ADDENDUM NO. 01

DATE 06.19.2014

PROJECT VMDO Project No.1115, Renovation of Three Residence Halls
PC# 217-17565-001

SECOND AND THIRD FLOOR - 1/2 HR RATED CHASE

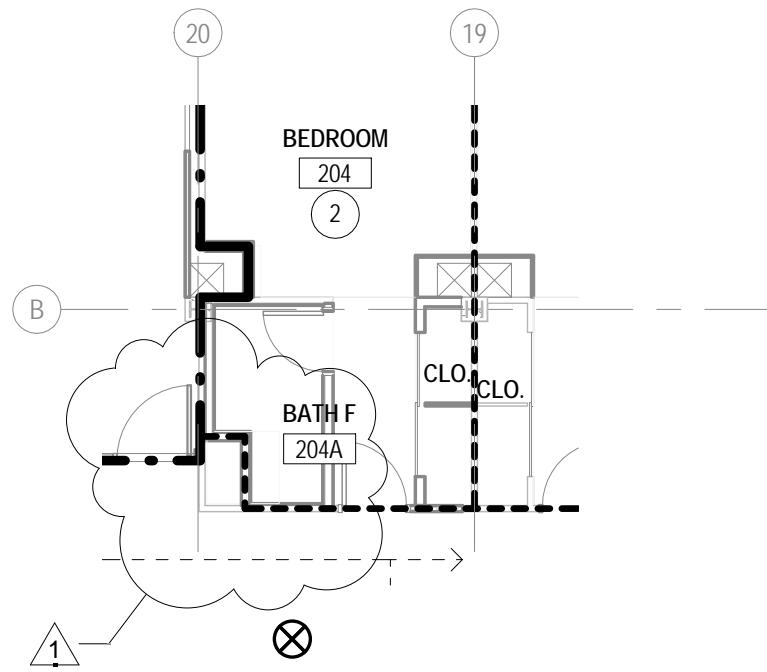
2.11 Revise $\frac{1}{2}$ hour rated wall around bathroom s 204 and 304 per attached Sketch **FSK-02.**

SIDEWALL SPRINKLER INSTALLATION DETAIL

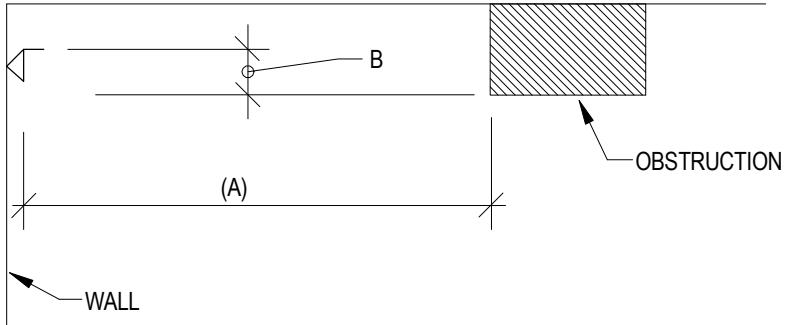
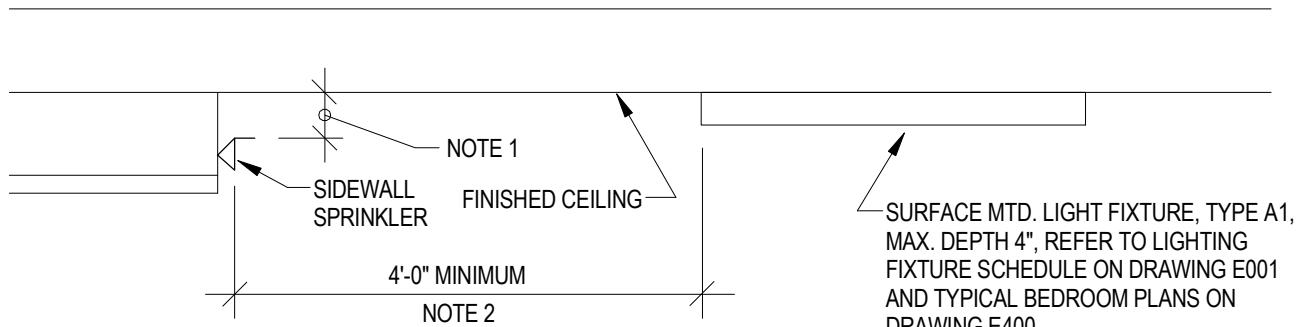
2.12 Add Sidewall Sprinkler Installation Detail and Positioning Table. Refer to attached sketch **SPSK-1.**

NOTE 1: SIDEWALL SPRINKLERS SHALL BE INSTALLED NO LESS THAN 4 INCHES AND NO MORE THAN 6 INCHES BELOW CEILING UNLESS APPROVED OTHERWISE BY THE A/E AND THE STATE BUILDING OFFICIAL.

NOTE 2: NO OBSTRUCTIONS, ONLY SMOOTH FLAT CEILING, IS ALLOWED WITHIN 4 LINEAL FOOT OF THE SPRINKLER.

REVISED HORIZONTAL FAN COIL UNIT COIL CONNECTION DETAIL

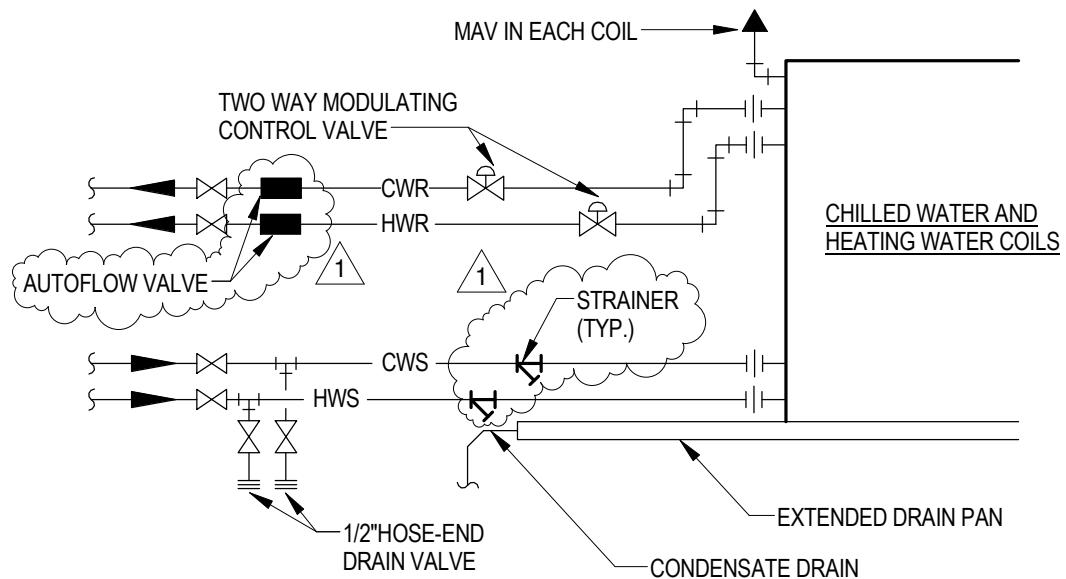
2.39 Add autoflow valves and strainers to horizontal fan coil unit coil connection detail. Refer to attached sketch MSK-7.

REVISED FIN TUBE RADIATOR COIL DETAIL

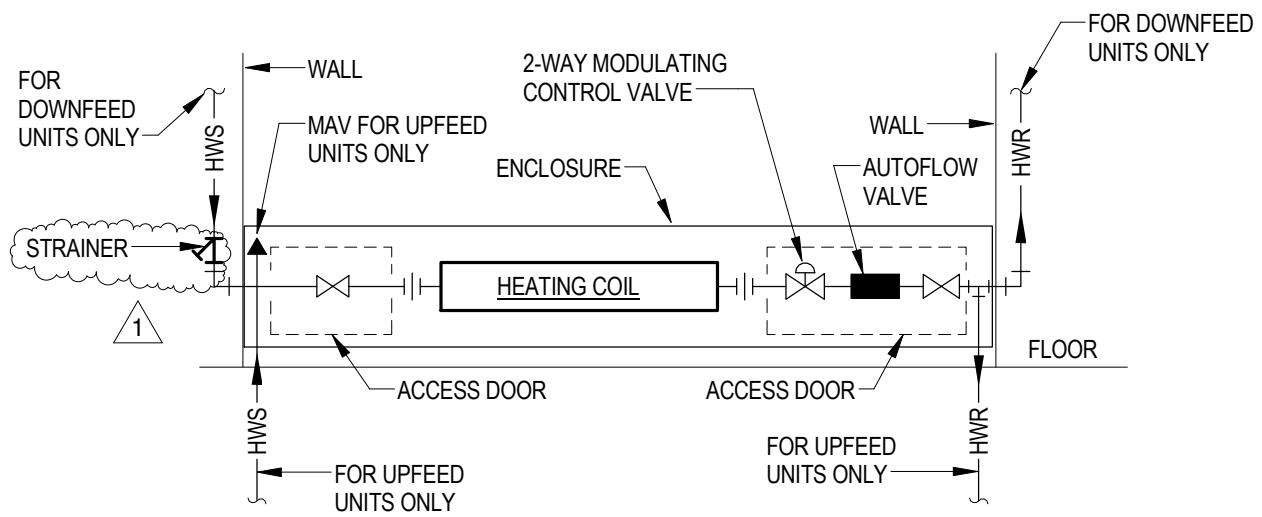
2.40 Add strainer to fin tube radiator detail. Refer to attached sketch **MSK-8**.

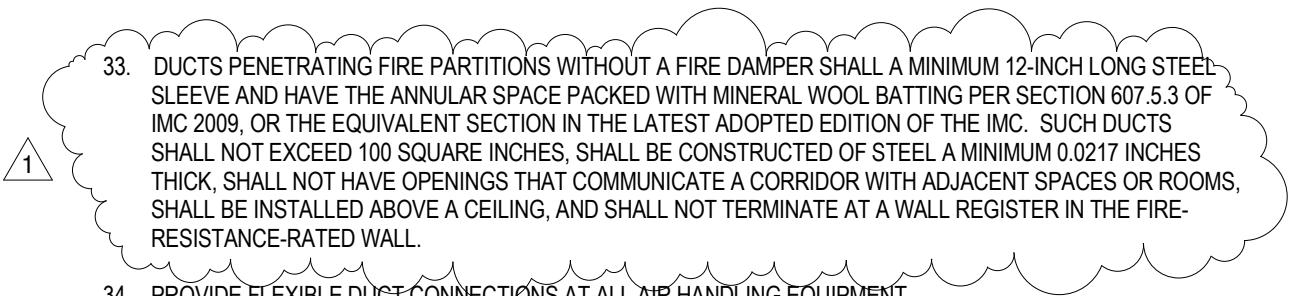
2.13 Modify general notes #33 and #35. Refer to attached sketch **MSK-9.**

- 
- 1
33. DUCTS PENETRATING FIRE PARTITIONS WITHOUT A FIRE DAMPER SHALL HAVE A MINIMUM 12-INCH LONG STEEL SLEEVE AND HAVE THE ANNULAR SPACE PACKED WITH MINERAL WOOL BATTING PER SECTION 607.5.3 OF IMC 2009, OR THE EQUIVALENT SECTION IN THE LATEST ADOPTED EDITION OF THE IMC. SUCH DUCTS SHALL NOT EXCEED 100 SQUARE INCHES, SHALL BE CONSTRUCTED OF STEEL A MINIMUM 0.0217 INCHES THICK, SHALL NOT HAVE OPENINGS THAT COMMUNICATE A CORRIDOR WITH ADJACENT SPACES OR ROOMS, SHALL BE INSTALLED ABOVE A CEILING, AND SHALL NOT TERMINATE AT A WALL REGISTER IN THE FIRE-RESISTANCE-RATED WALL.

34. PROVIDE FLEXIBLE DUCT CONNECTIONS AT ALL AIR HANDLING EQUIPMENT.
 35. DUCTS PENETRATING THREE STORIES SHALL BE PROTECTED WITH FIRE DAMPERS AT EACH FLOOR PENETRATION, AND THE ANNULAR SPACE AROUND THE DUCT AT EACH FLOOR PENETRATION SHALL BE PROTECTED WITH AN APPROVED NON-COMBUSTIBLE MATERIAL THAT RESISTS THE FREE PASSAGE OF FLAME AND THE PRODUCTS OF COMBUSTION IN ACCORDANCE WITH 2009 VCC SECTION 716.6.3.

SECOND AND THIRD
FLOOR DUCTWORK
PLANS

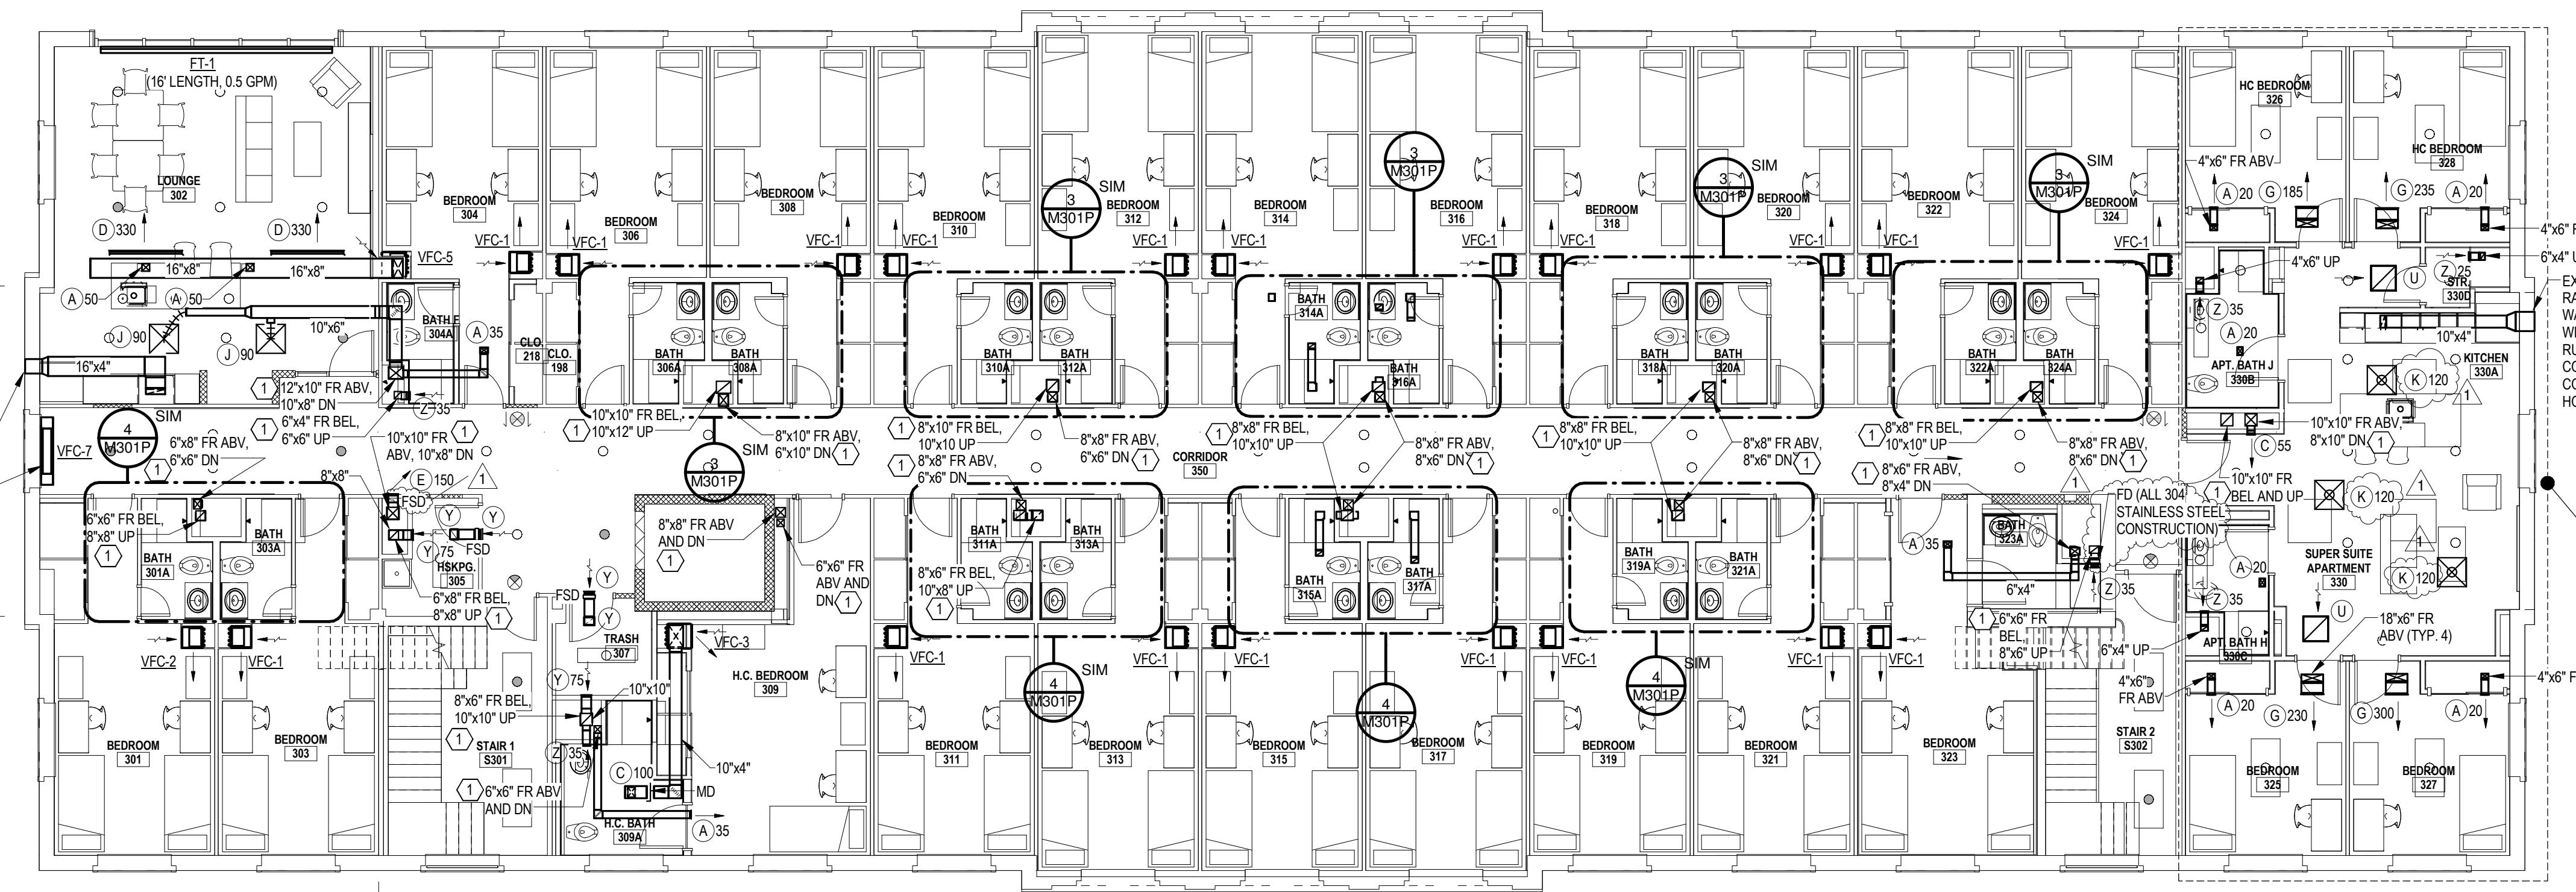
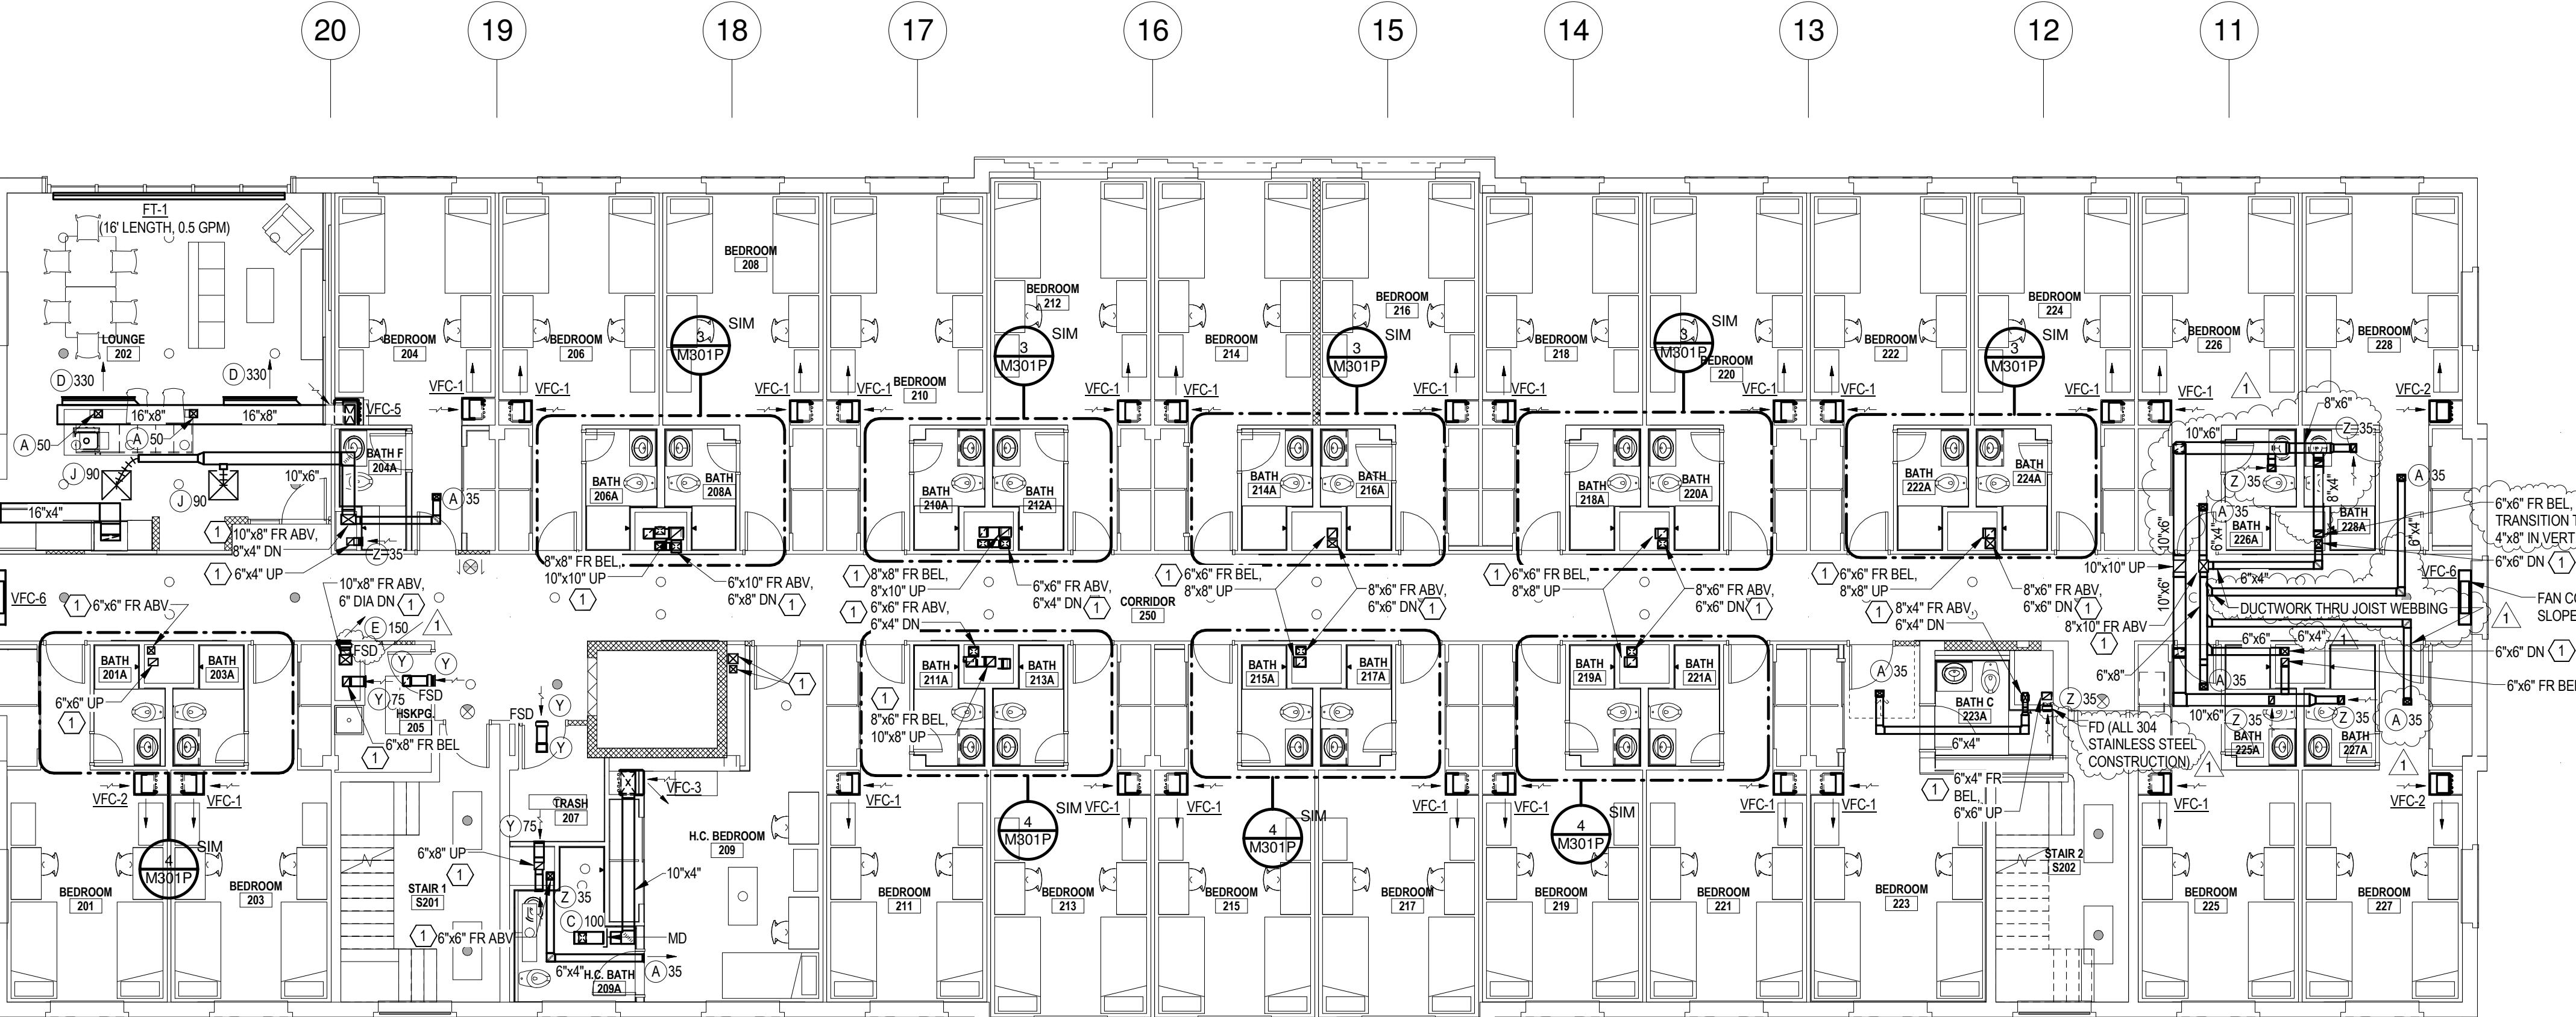
2.20 Add fire dampers on floors 2 and 3 and modify ductwork routing on second floor. Refer to attached revised Sheet **M102**.

2.21 Modify airflow quantities in third floor apartment. Refer to attached revised sheet M102

1. PROVIDE FIRE DAMPER AT FLOOR PENETRATION.
